Access Compliance Report Public Rights-of-Way (Curb Ramps)

Main Street: SIERRA_ALTA_DR Cross Street: RED_HILL_AVE Location: SE

ADA ID: RPRK211014173615 Ramp Type: Type 6 - Directional 1 Initial Pass/Fail: Pass Overall Compliance: No Severity Score: 10

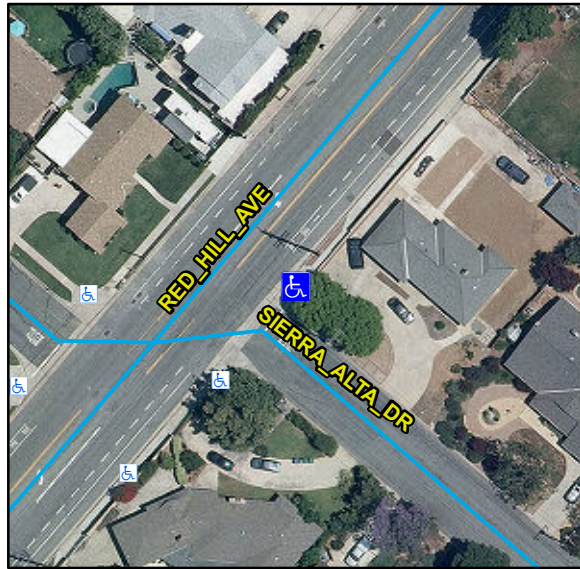
Compliance	Description	Data	Compliance	Description	Data
N/A	Ramp Length (in)	193	N/A	Flare Type LT	
Yes	Ramp Width (in)	48			Sloped
Yes	Ramp Run Slope (%)	6.6	N/A	Flare Slope LT (%)	6.7
Yes	Ramp Cross Slope (%)	0.7	N/A	Flare Traversable LT	No
Yes	Grade Break	Yes	Yes	Flare Type RT	
Yes	Grade Break Slope (%)	2.1			Curbed2
No	Grade Break Cross Slope (%)	2.3	N/A	Flare Slope RT (%)	N/A
	Addl Para Ramp Left?	No	N/A	Flare Traversable RT	N/A
	Addl Para Ramp Right?	No	No	DWS Provided	No
N/A	Landing Present	Yes	N/A	DWS Contrast	N/A
Yes	Landing Length (in)	60	N/A	DWS Length (in)	N/A
Yes	Landing Width (in)	48	N/A	DWS Full Width	N/A
Yes	Landing Run Slope (%)	0.9		DWS Offset Type	N/A
Yes	Landing Cross Slope (%)	1.2	N/A	DWS Left Offset (in)	N/A
N/A	Landing Movement Obstructed?	No	N/A	DWS Right Offset (in)	N/A
	Landing Movement Type	N/A			
N/A	Landing Shared	No			
N/A	Marked Crosswalk 1	No	N/A	Clear Space	N/A
	Crossing 1 Direction	SW	N/A	Clear Space To Crosswalk (in)	N/A

Marked Crosswalk 1 Width (in)	N/A			
N/A	Ramp Inside Crosswalk 1	N/A			
	Crossing 1 Slope (%)	1.1			
	Crossing 1 Cross Slope (%)	1.9			
Yes	Gutter Ponding	No	Yes	Curb Slope	5.8
Yes	Gutter Lip Height (in)	0		Road Run Slope (%)	N/A
Yes	Gutter Run Slope (%)	1.8		Road Cross Slope (%)	N/A
No	Gutter Cross Slope (%)	3		Parallel Ramp Side	Right
Yes	Overall Surface Condition	Acceptable	Yes	Perp Joint Present	Yes
	Cross Gutter Present?	Yes		Spandrel Present?	Yes
	Replace Cross Gutter?	No		Replace Spandrel?	No

Remove & Replace Entire Ramp. Remove & Replace Gutter.

R304.5.3, R305, STD 1115
